Burlington Development Review Board

BURLINGTON DEVELOPMENT REVIEW BOARD

MEMORANDUM

RE: ZP-23-205; 655 Spear Street

Site Plan

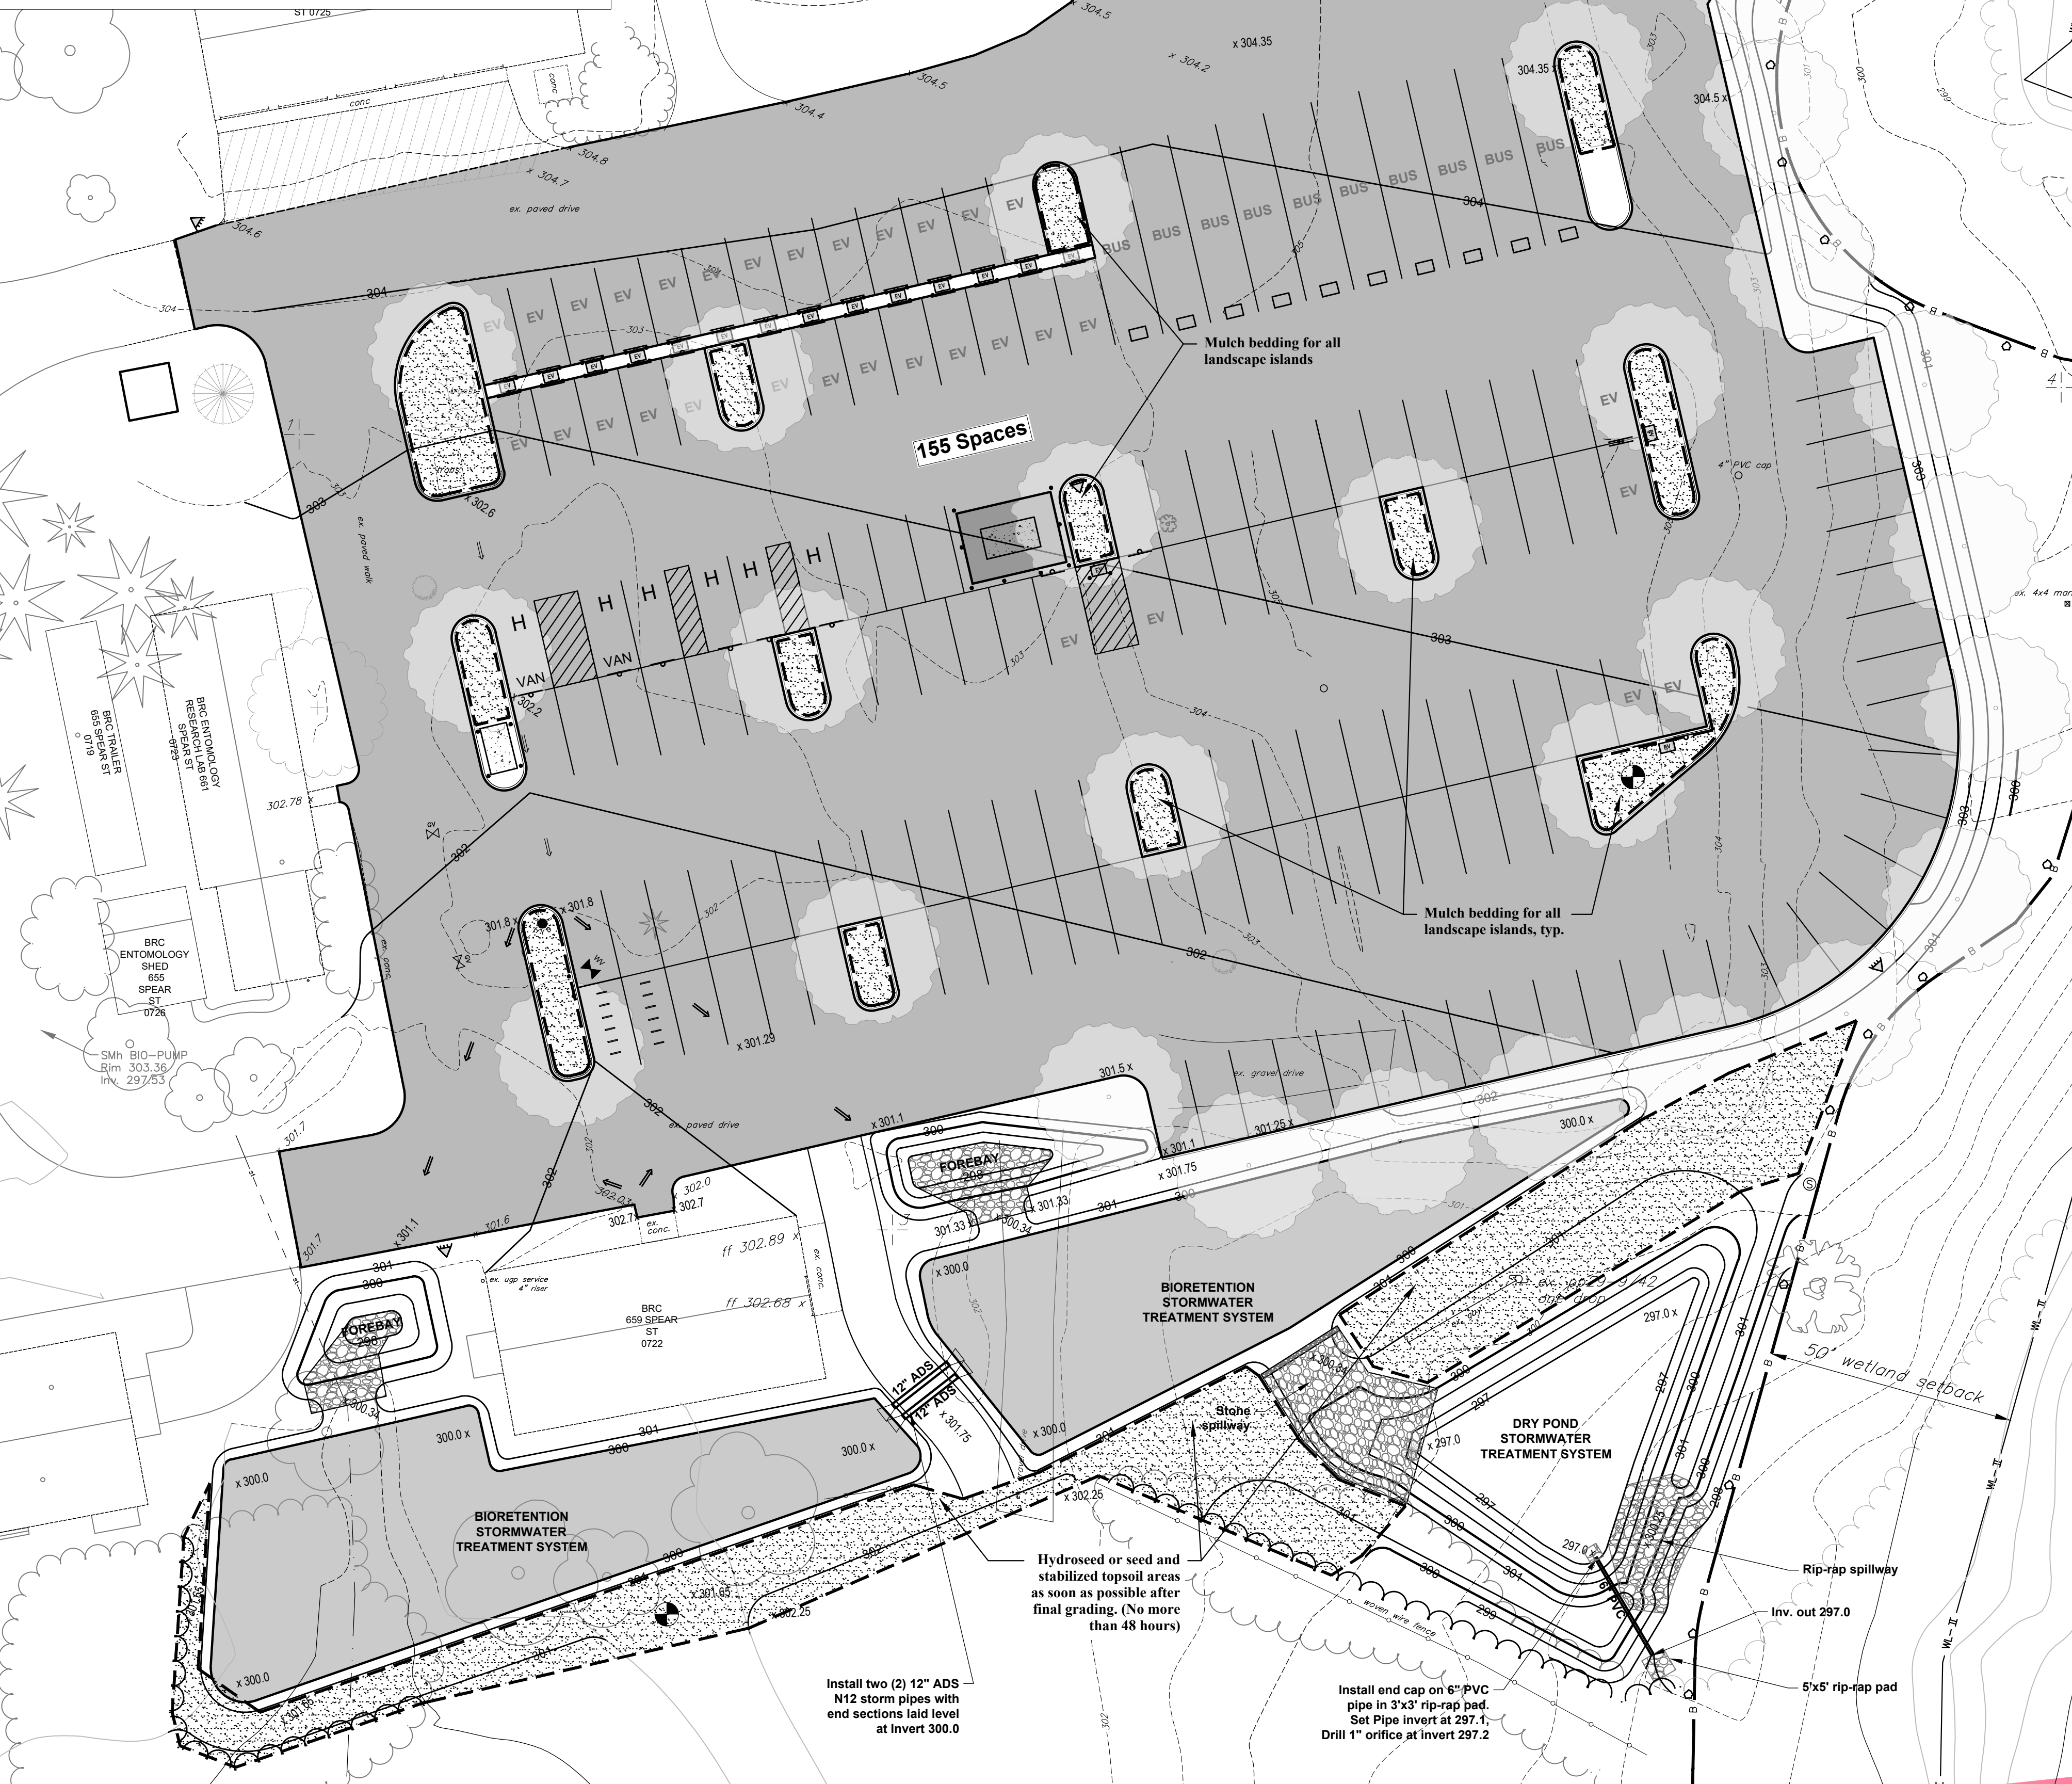
Generalized site work is proposed; reference is made to Plan C 1.0 (Civil) for details. An Erosion Prevention and Sediment Control Plan is required; approval by the Stormwater Program engineer a condition of approval. **Affirmative finding as conditioned.**

The new parking lot is intended primarily for fleet vehicles (busses, EV spaces) as well as accommodations for on-site staff. Revisions were made to the site plan to account for ADA. Any requirements towards ADA is under the jurisdiction of the building official. **Affirmative finding as conditioned.**

The new parking area is accessed from the existing Bioresearch Drive. See Plan C 1.0.

Landscape and Post-Construction Soil Depth & Quality Plan

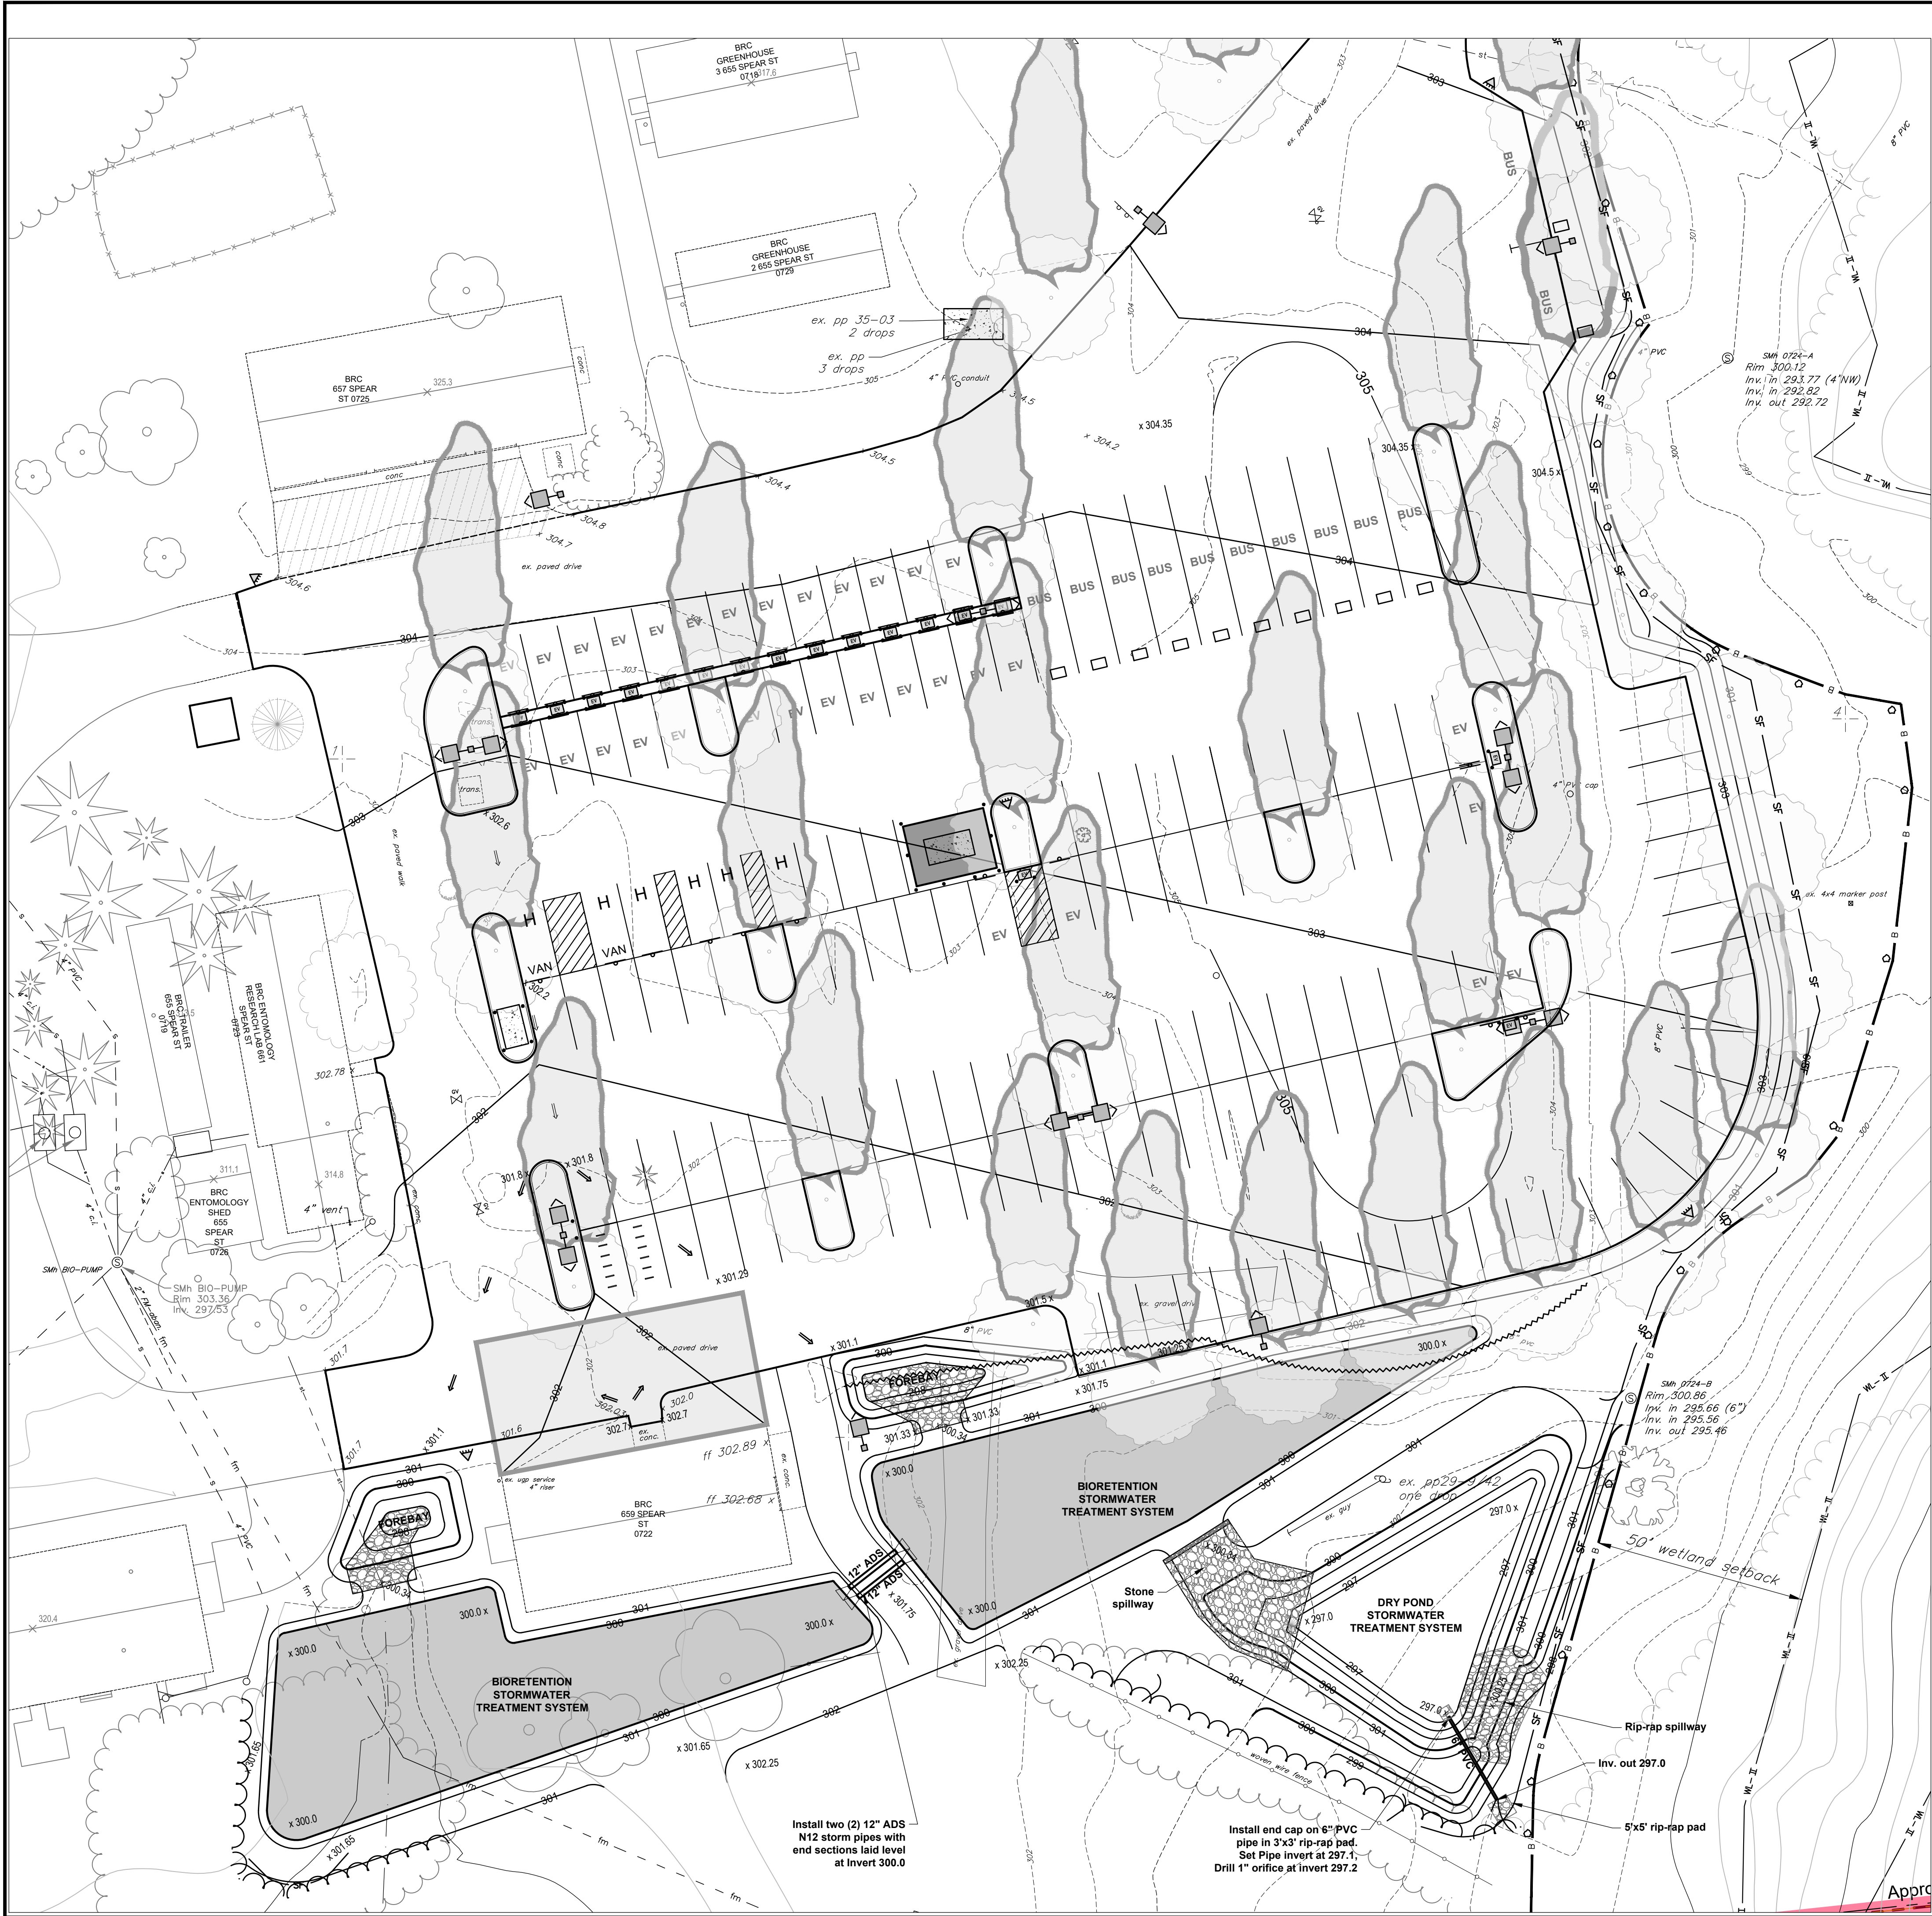
Plan L1.1 has been revised to reflect the required tree planting (see calculation at right). Two additional trees have been added to eliminate the earlier request for a tree planting waiver. Parking lot shading continues to exceed the 30% requirement.

Reference is made to Plans L 1.0 and L 1.1. The proposed caliper size is compliant with the standards. The application includes installation of a silt fence for erosion control during construction and permanent buffer demarcation with boulders. **Affirmative finding.**
